Re: Tier 2 Pathway Application: Application No. B0198

Leadership Counsel for Justice and Accountability, Public Justice, and the Animal Legal Defense Fund write in opposition to this application from California Bioenergy LLC for the following reasons: (1) there is a lack of available data (2) the lifecycle analysis is incomplete (3) the project will increase air pollution and threatens water quality in the locality and region, thus undermining the state's climate, environmental justice, and equity goals, (4) the project will contribute to methane leakage from transport of gas, (5) this project will incentivize the production of methane, and (6) the reductions from the five dairies in this application are not additional and CARB should disallow LCFS credits.

Exhibit 4. Aerial Map of Kern Cluster

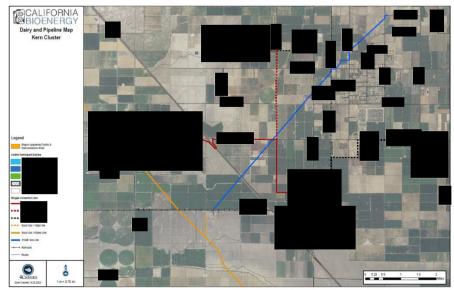
The applicants and/or the California Air Resources Control Board (CARB) withheld and redacted information regarding calculations related to Life Cycle Results for Carbon Intensity such that it is impossible to determine the air quality and water quality impacts and the carbon intensity value:

Such data must be available in order to transparently access the potential harms and supposed benefits of this proposed pathway.
